Access Compliance Report Public Rights-of-Way (Curb Ramps)

Main Street: AIROSO_ST Cross Street: CHIQUITA_CANYON_DR Location: NE

ADA ID: RPRK211130123401 Ramp Type: Type 1 - Perpendicular Diagonal Initial Pass/Fail: Pass Overall Compliance: No Severity Score: 0

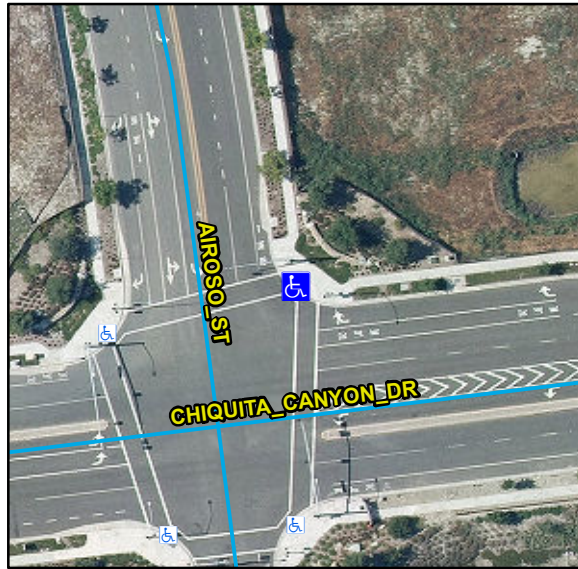
Remove & Replace Landing. Remove & Replace Gutter.

R304.2.2-Perp, R304.3.2-Para, R304.5.3, STD 1115
